HAM IR71 1.81 Pedestrian Bridge

PID 102790

VIRTUAL OPEN HOUSE SUMMARY REPORT

*Prepared for
ODOT District 8
August 2022*

ALTERNATIVE 1

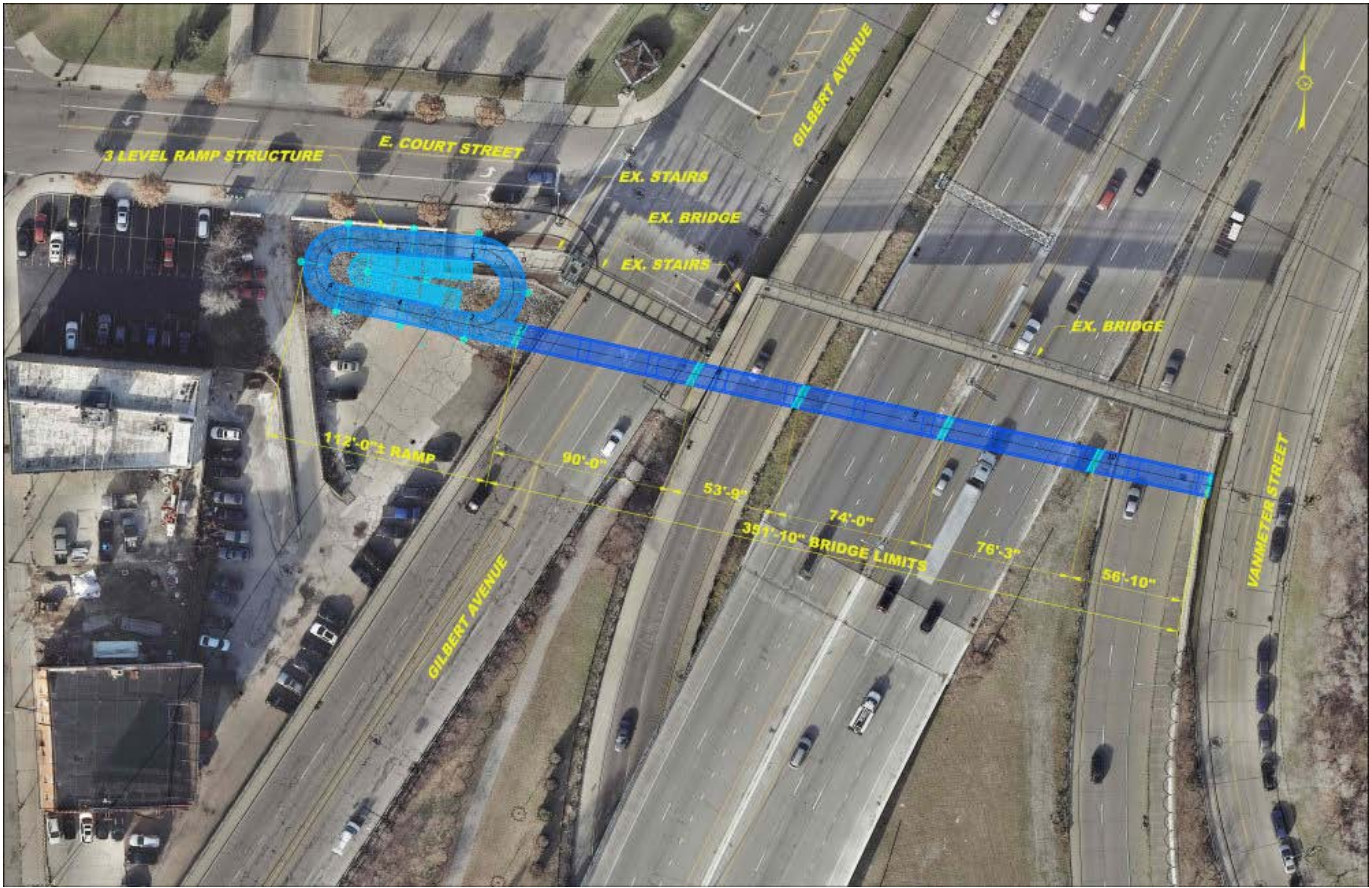
Q10 Theme	Count	Descriptors
<i>Aesthetics*</i>	69	Design shown in renderings is too basic; looks like it's a structure for cars or for parking; better aesthetic elements are needed/wanted; consider partner with outside organizations to improve and/or fund aesthetic enhancements; consider incorporating artwork on bridge; keep art deco theme; add landscaping
<i>Ramp</i>	20	The ramp looks long and intense; may be overwhelming or daunting due to size; may be frustrating for those on bicycles or in wheelchairs; may attract nuisances like skateboarders
<i>Fencing</i>	13	Would like better fencing options; get rid of chain link
<i>No</i>	12	No concerns
<i>Gateway</i>	10	Opportunity to serve as/create gateway to city
<i>Safety</i>	7	Security is an issue in the landing area, esp in evening; concerns about maintaining personal safety; concern about keeping ramp safe (may create hiding spaces)
<i>Wider</i>	7	Needs to be wide enough to accommodate a variety of travel modes moving in opposite directions; new design doesn't look wide enough; could be wider

1. That ramp takes up so much space. Is there another way to achieve that? The stair entrance is in a less convenient location than the current bridge. It looks like with this design you have to walk around to get to the stairs? This looks very utilitarian and doesn't add anything to the aesthetic of the city.
2. Going over the highway, I put some time of visual railing up 3 or 4 feet for those afraid of heights. Chain link fence isn't that visually pleasing.
3. It is convenient to have steps in addition to the circular ramp, as it adds to walking time if you are on foot and have to take the ramp round and round. A set of steps next to the ramp that goes straight to the top would be faster and more convenient for walkers/runners.

3. ADA ramp takes too much space due to height of bridge. Is it really worth doing?
4. That ramp takes up so much space. Is there another way to achieve that? The stair entrance is in a less convenient location than the current bridge. It looks like with this design you have to walk around to get to the stairs? This looks very utilitarian and doesn't add anything to the aesthetic of the city.

6. Following up on my initial comment... the exit onto E. Court St. makes sense, but can Alternative #1 also be linked up to the shared-use path on Eggleston via a secondary exit? It looks like there could be space behind the building at 824 Reedy Street, pending issues around parking spaces and property owner cooperation.

1. Please say there is an alternative to the chain link fence!
2. The current bridge is going to be demo before the new proposal.
3. I reckon it's necessary to have all the loops at the downtown end for accessibility but that would make it a longer way to go to reach street level at the downtown end. Wondering if there could be a stairway added on for those that want to travel a bit faster. Wonder if an elevator could be added for quick access to the ground level. A clear open view elevator so that no one could hide on it to commit a crime.

ALTERNATIVE 2

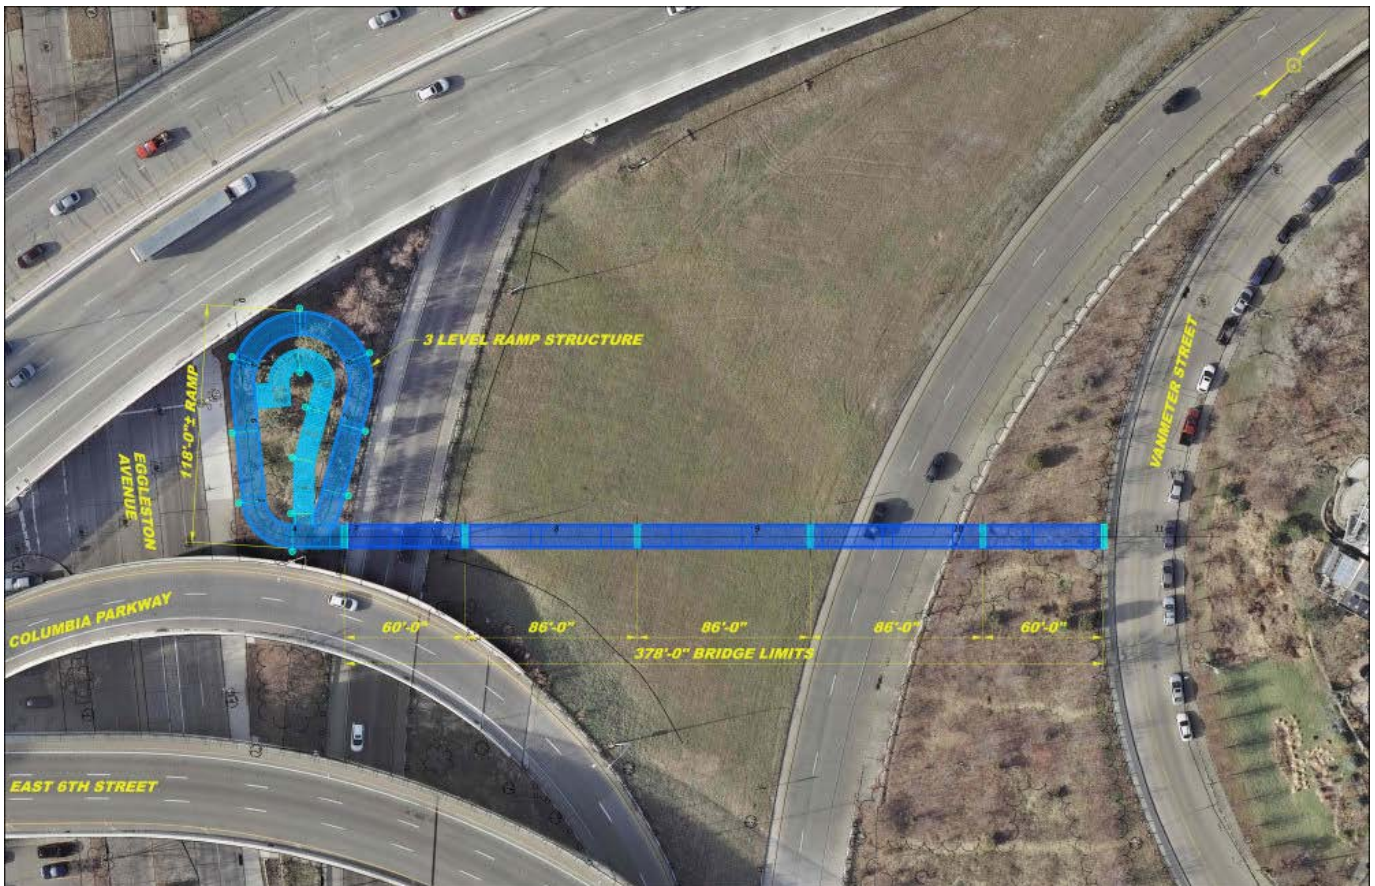
<i>Aesthetics</i>	20	Too plain, bland, utilitarian, ugly; has no character, sense of place; design needs work/improvement; prefer gateway look of the existing bridge; fencing is not appealing; chain link fence is unsightly; add more design, murals maybe; add some park-like spaces at the ends
<i>Noise</i>	10	Noise level from highway overpasses, nearby roads is a concern; traffic noise will be loud
<i>Pedestrian</i>	6	Landing area is not pedestrian friendly; has poor access to pedestrian paths; Alternative 2 would concentrate pedestrian walkways in southern portion of city, creating less pedestrian-

2. Would the grade be too steep for wheelchair use?
3. Too close to existing 6th street ramp on east end. Can you provide connection to Eggleston from existing ramp?
